**Final Submissions**  
**for the**  
**Royal Society for the Protection of Birds**  
**and Suffolk Wildlife Trust**

**Submitted for Deadline 10**  
**12 October 2021**

**Application by NNB Generation Company (SZC) Limited for an Order**  
**Granting Development Consent for**  
**The Sizewell C Project**

**Planning Inspectorate Ref: EN010012**  
**RSPB Registration Identification Ref: 20026628**  
**Suffolk Wildlife Trust Registration Identification Ref: 20026359**

Fig x: Extension of current northern mound perimeter fence onto RSPB land

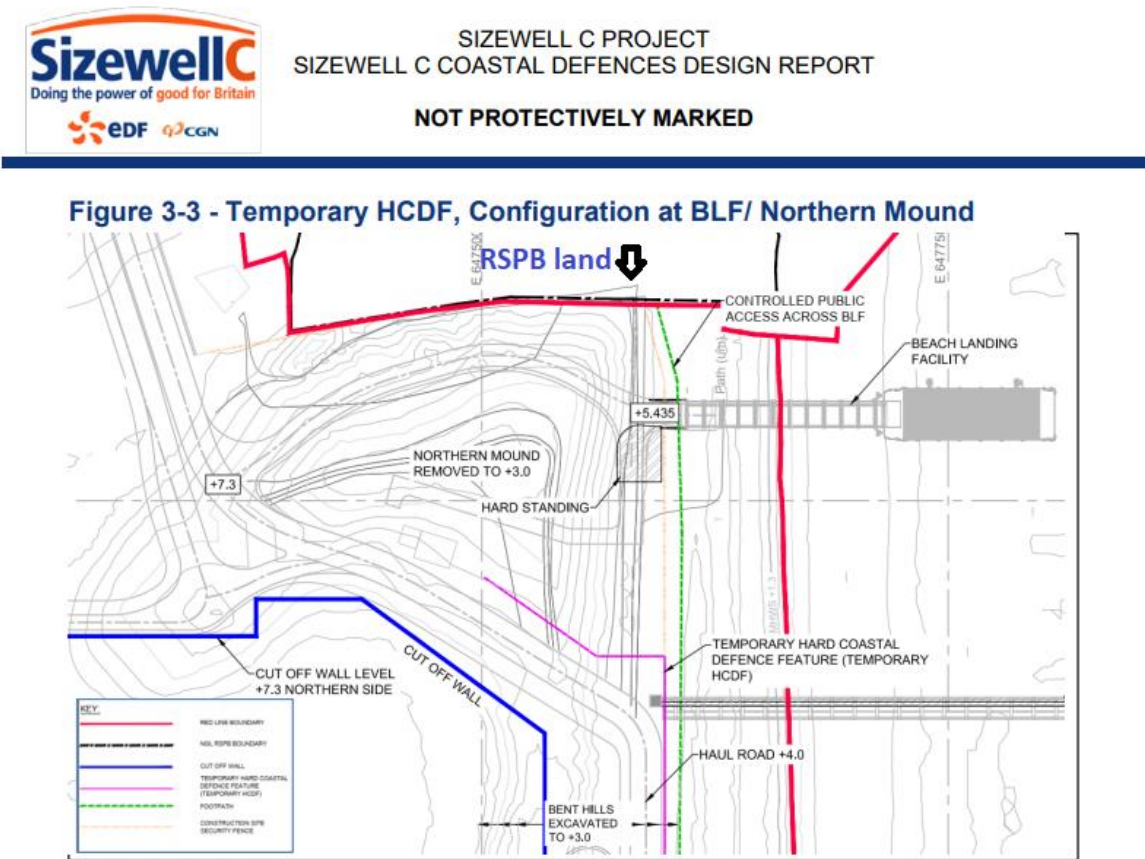
20.2. Fig 3.3 illustrates the removal of the northern mound. The north east corner of the current northern mound perimeter fence is on RSPB land, as represented by the triangular extension extending beyond the red line boundary (identified on the plan below (fig x)). RSPB requires further clarification that there will be no impact on its land interests in this area.
